Additional Project Scope & Revised Total Project Costs - Capital Project: Report of the Project Planning Committee for the University College Revitalization (Revised Phase 1) and Croft Chapter House (Phase 2)

November 11, 2016

University College Revitalization (Revised Phase 1) and Croft Chapter House (Phase 2): Additional Project Scope

University College Basement Floor Plan

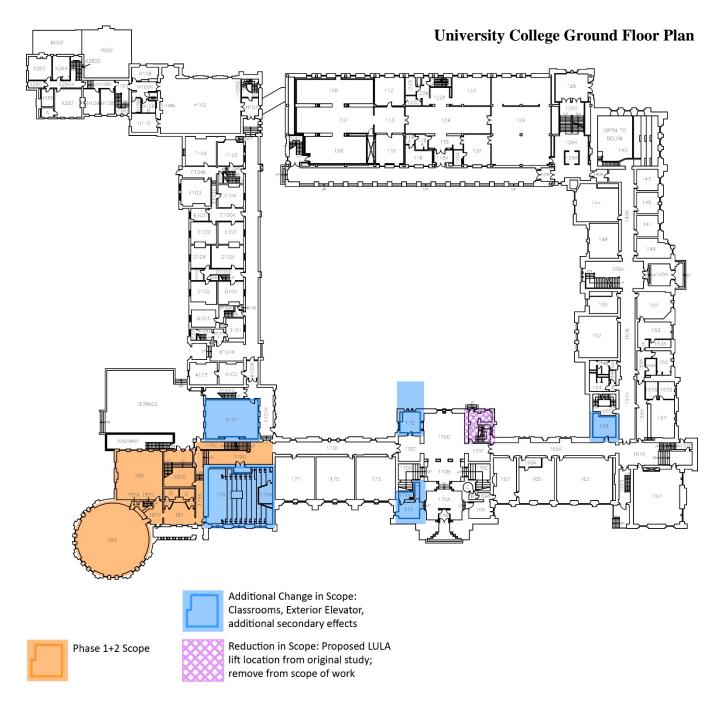
Additional Change in Scope: Full Service Elevator, related secondary effects

Reduction in Scope: Proposed LULA lift location from original study; remove from scope of work

- New full service elevator in area of Room 80 (existing Janitor lounge)
- New relocated Janitor's lounge in F001
- Removal of LULA area from scope

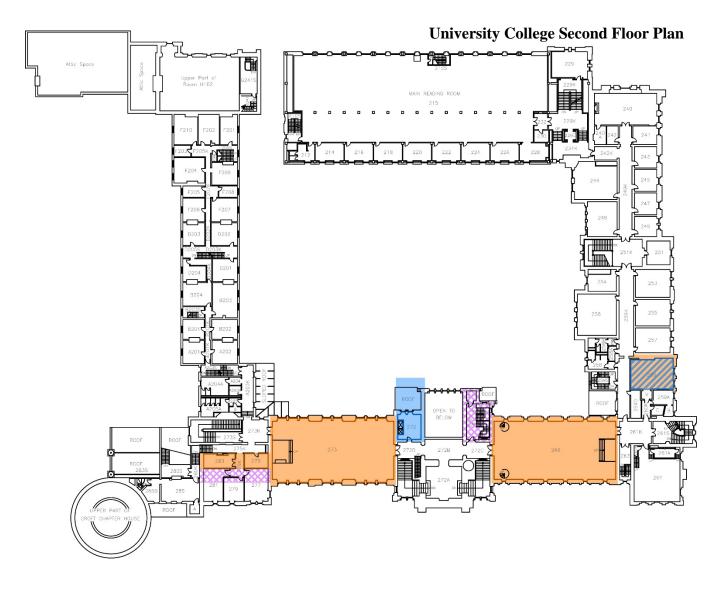
- Renovation to classrooms UC179 & UC A101
- New full service elevator in UC 172, secondary effects including UC 158 & UC 171, 171A, 171B
- Removal of LULA area from scope

Additional Change in Scope: Classrooms, Exterior Elevator, additional secondary effects

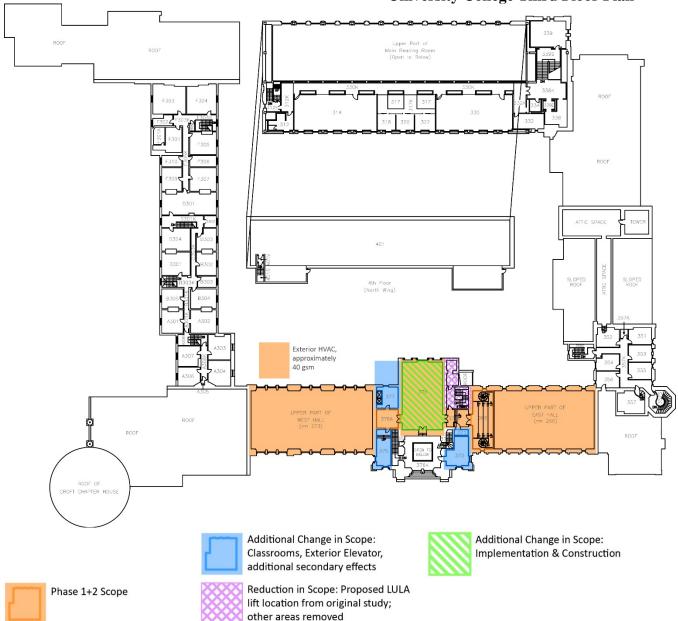
Reduction in Scope: Proposed LULA lift location from original study; other areas removed

- New full service elevator (exterior), and secondary effects including UC 272
- Removal of LULA area from scope
- Removal of unneeded support space for libraries
